JRPP No	2011SYW046
DA Number	DA0147/11
Local Government Area	Ku-ring-gai Council
Proposed Development	New practice fairway, construction of new holes, various hole design changes, new water storage dam & bridge, tree removal, landscaping works and associated works to existing golf club
Street Address	556 Pacific Highway Killara
Applicant/Owner	Killara Golf Club Limited
Number of Submissions	78 plus a petition containing 130 signatures – original DA 21 – amended proposal
Recommendation	Approval
Report by	Ross Edwards, Development Assessment Officer

SUMMARY SHEET

REPORT TITLE:	556 Pacific Highway, Killara
LOT & DP:	Lot 2 in DP 1109896 Lot 1 in DP 233290 Lot 1 in DP 518001 Lot 9 in DP 3725 Lot 4 in DP 404775 Lot B in DP 412102 Lot C in DP 329128 Lot 2 in DP 535219 Lot 22 in DP 217659
PROPOSAL:	New practice fairway, construction of new holes, various hole design changes, new water storage dam & bridge, tree removal, landscaping works and associated works to existing golf club
DEVELOPMENT APPLICATION:	DA0147/11
WARD:	Gordon
APPLICANT:	Killara Golf Club Limited
OWNER:	Killara Golf Club Limited
DATE LODGED:	1 April 2011
ESTIMATED COST OF DEVELOPMENT:	\$14,350,000
ISSUES:	Landscaping, ec

Figure 8: Tree H5-184 is an excellent specimen of a remnant *Eucalyptus pilularis* (Blackbutt) located adjacent to the 5th green.

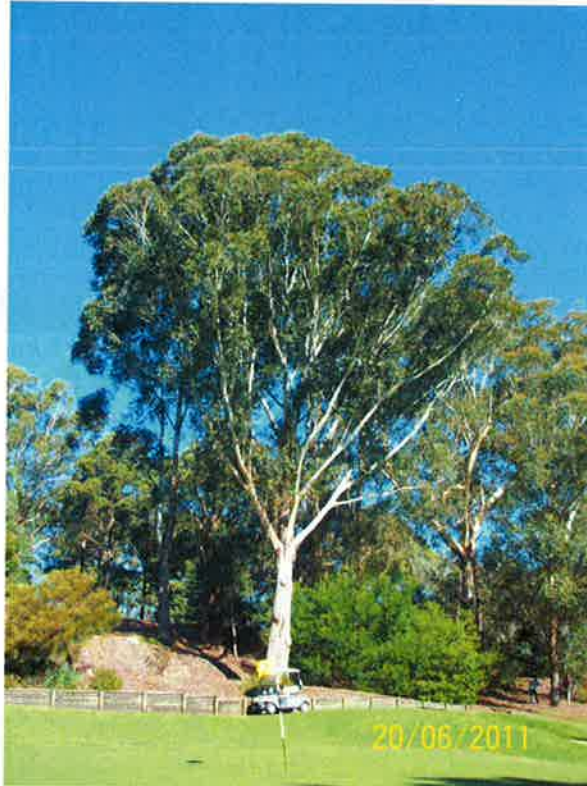
H5-184 is a remnant *Eucalyptus pilularis* (Blackbutt) located adjacent to the southern side of the 5th green (refer **Figure 8**). The tree is in excellent health and condition and considered significant within the broader landscape setting. The tree is assessed by the applicant's consultants as having a 'very high retention value' and a 'negligible' hazard rating. The tree's high canopy does not hinder the playability of the hole or approach to the green. The tree is proposed to be pruned up to 15% on its southern side to accommodate high approach shots to the

relocated green. The redesign and relocation of the green has not taken into consideration the existing retaining wall and cart path which conflict with the proposed bunker and green. It therefore has been conditioned for the existing retaining wall and cart path to be retained and the proposed bunker and green redesigned/relocated to accommodate the existing structures **(Condition 42)**. Pruning of the tree will as per the arborist's recommendations has been conditioned. **(Condition 78)**

Figure 9: Trees H4-181A, 183 & 184 in background and H4-181 in foreground on right hand side.

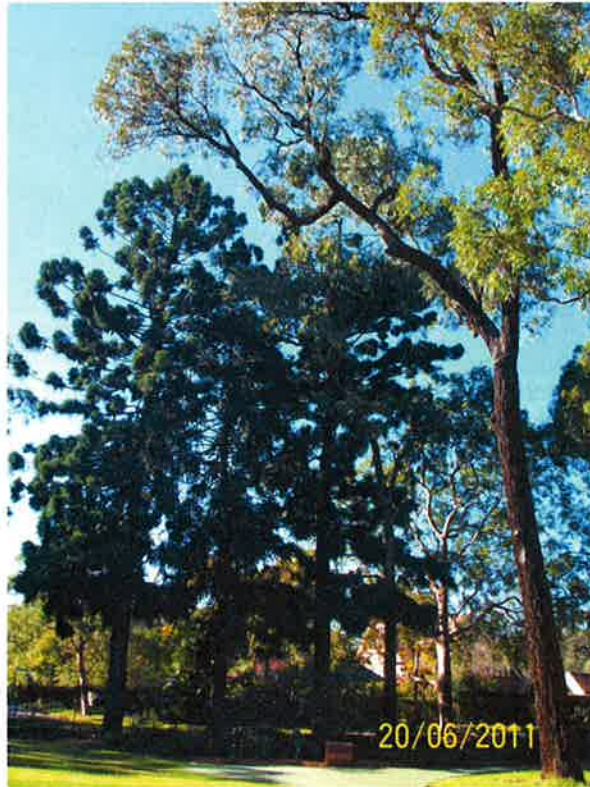
H4-181A, 183 & 184 is a small grouping of mature *Araucaria cunninghamii* (Hoop Pine) and *Araucaria bidwillii* (Bunya Pine) located adjacent to the eastern site boundary adjacent to the tee (Tree H4-181A is not shown on plan), at the corner of Mildura St and Links Rd (refer Figure 9). The trees are in excellent health and condition and visually significant within the Links Rd streetscape. It is proposed to remove trees H4-183 and H4-182 is identified as being dead or previously removed. Site inspections have confirmed that Tree H4-182 has previously been removed. Tree H4-181A has been tagged/identified as H4-181 on site which is the same identification used for the *Eucalyptus sideroxylon* (Red Ironbark), and therefore has been referenced in this report as H4-181A. The arborist's reports

identify this tree as H4-182 which has also been identified as previously been removed. The removal of Tree H4-183 is acceptable due to maintenance issues regarding the size and hazard of the cones and overcrowding. The removal of H2-183 *Araucaria bidwillii* (Bunya Pine) will allow the two *Araucaria cunninghamii* (Hoop Pine) to properly develop while improving airflow and morning sun to the tee.

Figure 37: Trees H2 63 & 64 *Eucalyptus saligna* (Sydney Bluegum) which are part of the critically endangered Sydney Bluegum High Forest (SBGHF) plant community.

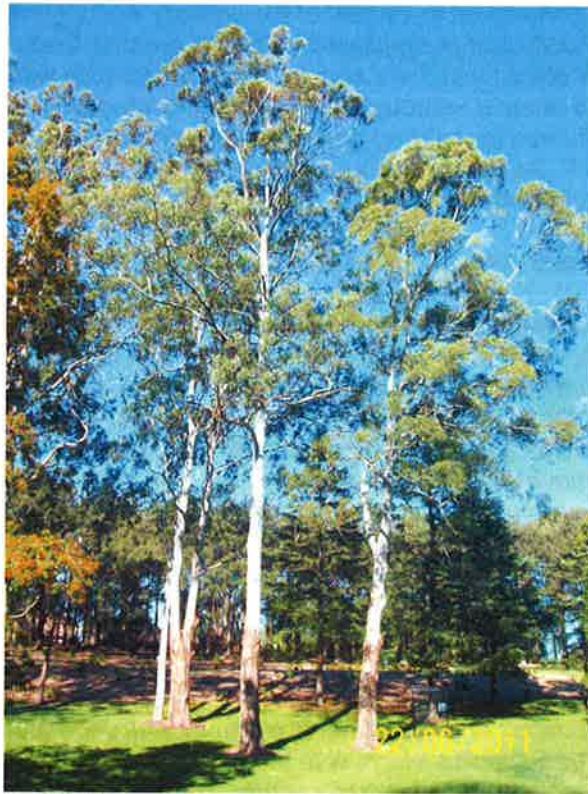
H2-63 & 64 Eucalyptus saligna (Sydney Bluegum) located adjacent to the existing 2nd green and adjacent to a proposed practice green, refer Figure 37. Amended plans indicate the trees to be retained, and have been identified as having a very high retention value by the applicant's arborist. The trees are assessed and identified within the ecological assessment as being remnant specimens and are

part of the critically endangered Sydney Bluegum High Forest (SBGHF). The trees are considered to be significant within the broader landscape setting and provide valuable amenity.

During the interval between amended plans being prepared and assessment of the application, H2-63 has dropped a very large diameter co-dominant stem caused by decay around the point of attachment. The project arborist has raised concern with suspected cavity and strength of attachment of the remaining co dominant stem and has recommended an aerial inspection and pruning of deadwood if the tree is to be retained.

- The proposed practice green and bunkers is to be amended to be consistent with the Practice Fairway Grading Plan #G.HPF, dated May 2012 to minimise impacts to tree's H2-63 and H2-64.
- The proposed cart path location adjacent to tree W-52 *Eucalyptus saligna* (Sydney Bluegum) is to be amended to be consistent with Figure 1 (Page 6) of the Addendum to the Arboricultural Development Impact Report, dated April 2012 by Urban Forestry Australia.
- The location of the proposed bunker adjacent to tree H10-125 *Sequoia sempervirens* (Californian Redwood) is to be amended so that it has a minimum setback of 8.0m from H10-125.
